Agenda Report

TO: CITY COUNCIL **DATE:** APRIL 11, 2005
FROM: CITY MANAGER
SUBJECT: PREDEVELOPMENT PLAN REVIEW FOR THE PROPOSED
SYMES TOYOTA DEALERSHIP LOCATED AT 3600 E. FOOTHILL
BOULEVARD

PREDEVELOPMENT PLAN REVIEW COMMENTS

Project Number: PPR2004-0049

SITE PLAN

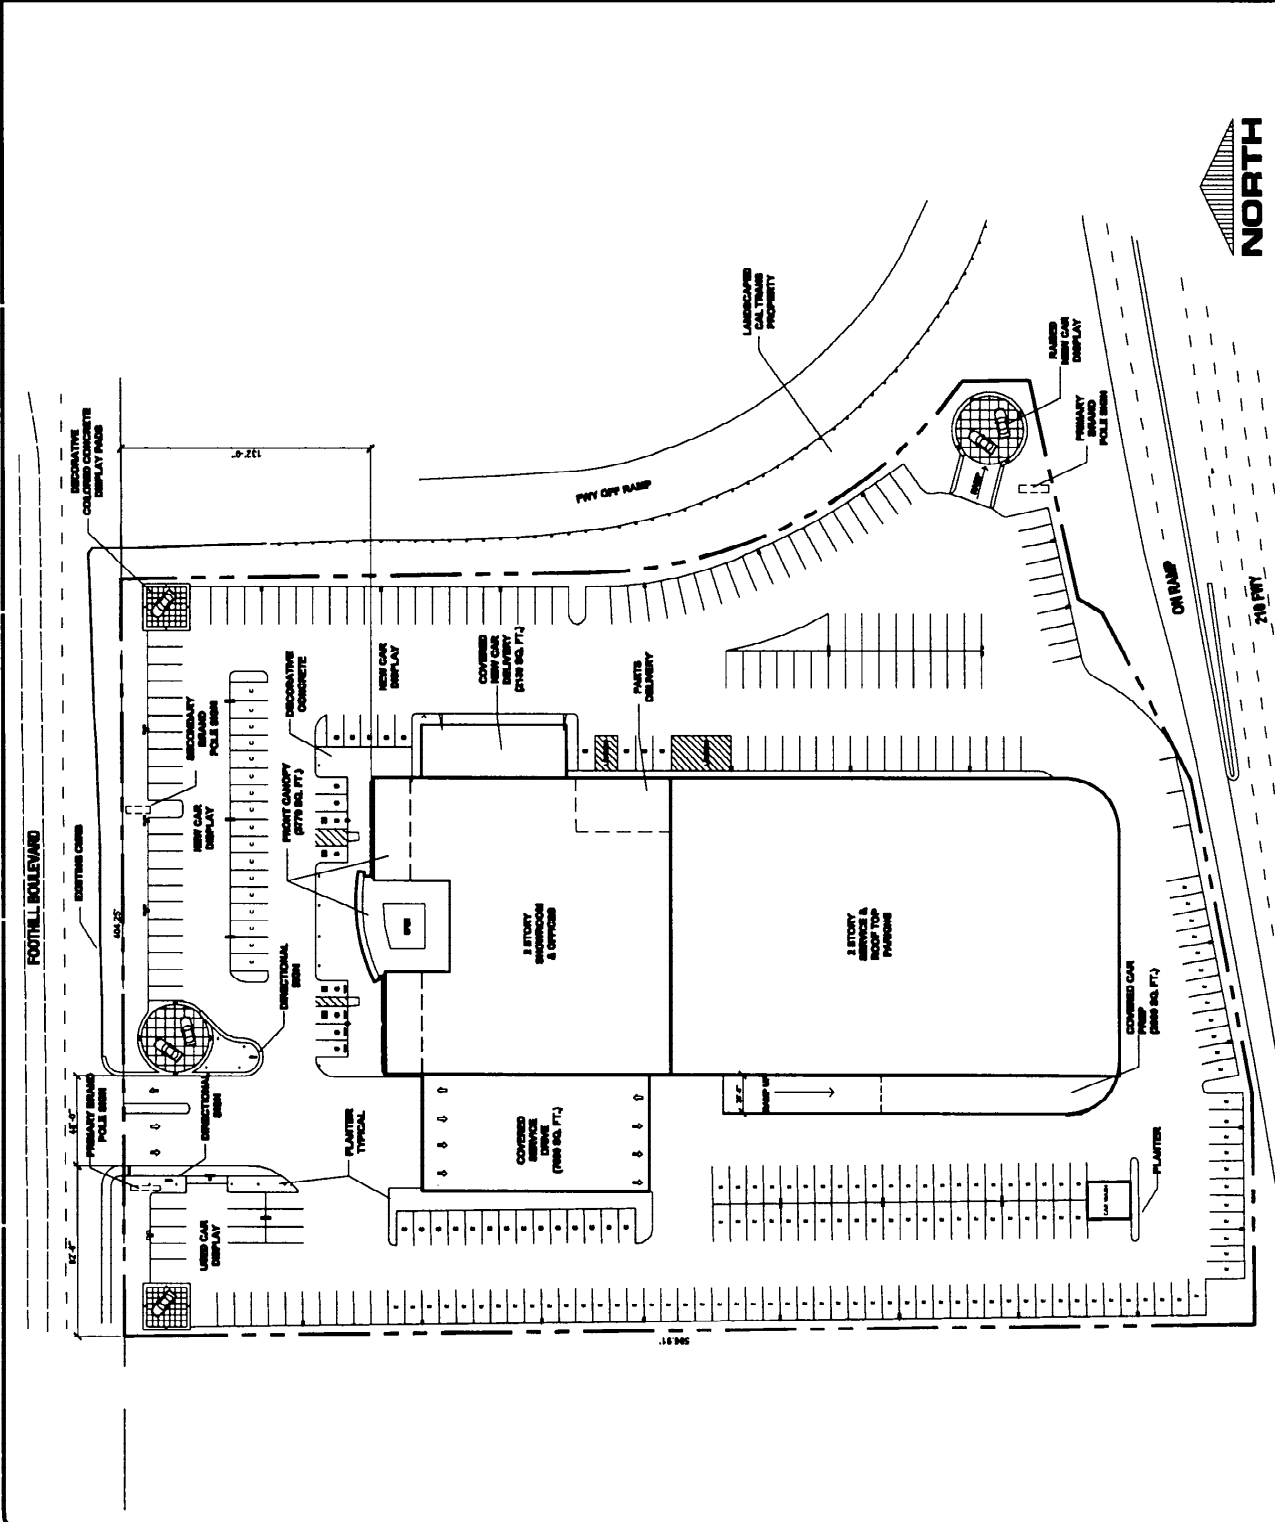
Note: Please be advised that the project data on Sheet 1 indicates that the total number of parking spaces provided to include vehicle storage would be 460 spaces while the actual calculation only come out to 370 spaces. Please revise accordingly.

Signage: Signage is shown on the site plans in a conceptual way only. All signs must meet the requirements of Section 17.48 (72) of the Zoning Code. Of those signs shown on the site plan, the number and some of the locations appear to not meet the requirements of Section 17.48 of the Zoning Code. In the IG zoning district freestanding signs are limited to one for each 250 lineal feet of property frontage. Also, to be considered property frontage, there must be access from a street or highway. Based on the number and location of signs that would be necessary for a business such as this, staff would suggest that a Master Sign Plan be submitted to the City for Review.

1. The current site plan shows only one driveway located near its western property line. A loading/unloading/turnaround space is provided in the rear (southeast-most of the property). If you look closely, it is questionable whether delivery trucks can get through aisles new cars to get to the turnaround space. We want to avoid and prohibit any loading of new cars in the two-way left-turn lane, which can be seen on Foothill Blvd. A secondary dwy (only to delivery trucks) to the eastern property line should be considered.
